Response to Submissions State Significant Development Application 7382

University of Technology Sydney

UTS Central Project

August 2016 ■ 15746

Figure 2 – Proposed Broadway interface

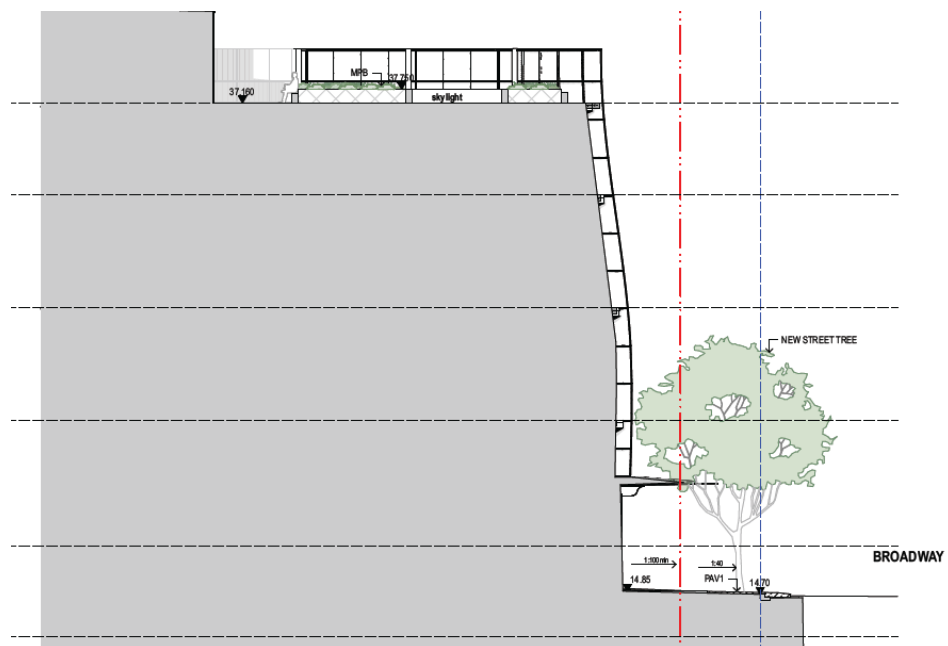
The Department has raised concern with the built form impacts on pedestrian movement around and through the site given the proposed minimal setback on Broadway. In this regard, additional information is sought regarding pedestrian movement and further demonstration that location of the bus stop will not interfere with pedestrian movement.

- The facade line at footpath level has been setback a minimum of 1.5m from the boundary along Broadway – providing for an overall 6m+ wide footpath (consistent with George Street footpath), refer to **Figure 2** below of proposed relationship of the podium to Broadway;
- The pedestrian movement and sight lines at the junction between the Broadway Building 1 entry and the bus stop have been improved by the proposed removal of the three Plane trees that are located behind the bus stop and within the path of travel.
- New street trees are proposed in accordance with the City of Sydney's Street tree masterplan to the full extent along the Broadway frontage.
